City of Richmond

Memorandum Planning and Development Division Development Applications

To: Mayor and Councillors
From: Joshua Reis
Director, Development
Date: August 25, 2026
File: RZ 23-015980
Re: Application by Manpreet Singh (ParaMorph Architecture Inc.) for Rezoning at 9720 Cambie Road from the "Small-Scale Multi-Unit Housing (RSM/XL)" Zone to the "Low Rise Rental Apartment (ZLR50) - Alexandra Neighbourhood (West Cambie)" Zone

Attachment 1

**SECOND
FLOOR PLAN**

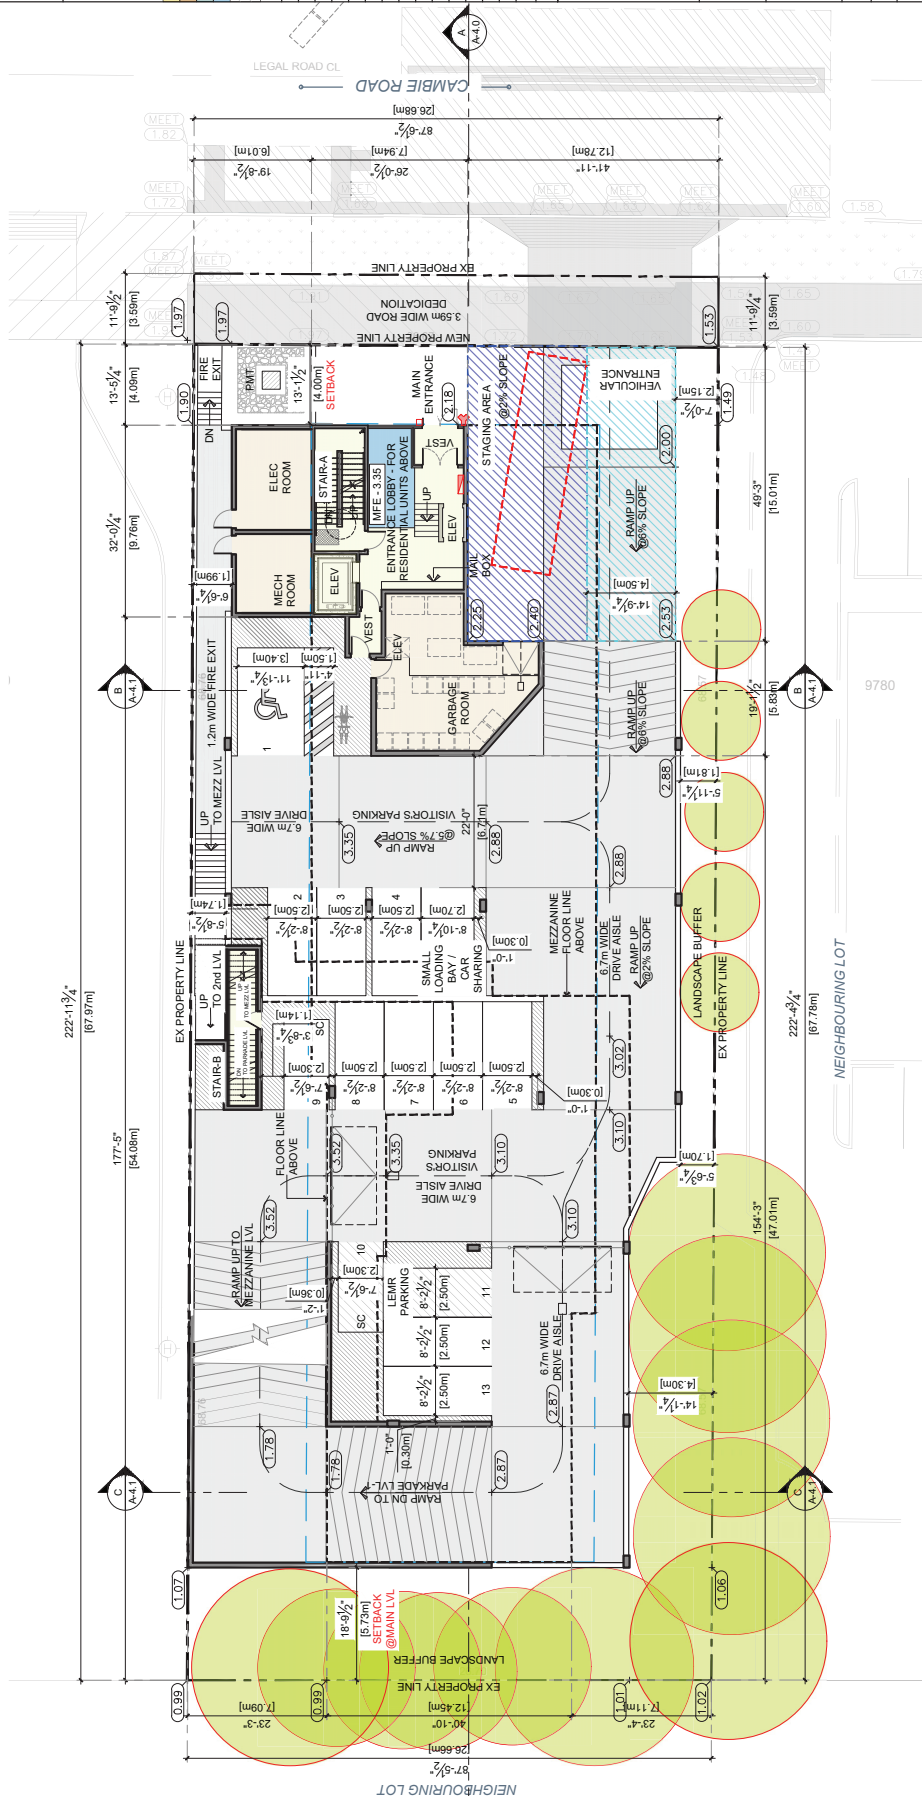
The original proposal included two LEMR units consisting of one studio unit and one two-bedroom unit. The revised proposal now includes two LEMR units consisting of one one-bedroom unit and one two-bedroom unit. In keeping with the provisions of the site-specific zone, the combined habitable space of all the affordable housing units proposed as part of the development is not less than 3.2 per cent of the total residential building Floor Area Ratio (FAR).

The applicant has provided updated conceptual plans (Attachment 1) that accommodate the revised unit mix.

LOW-END MARKET RENTAL REQUIREMENTS			
UNIT NUMBER	FLOOR LEVEL	UNIT TYPE	MINIMUM REQUIRED UNIT SIZE (Sqft)
107	SECOND LVL	2BR	741.00
111	SECOND LVL	1BR	400.00
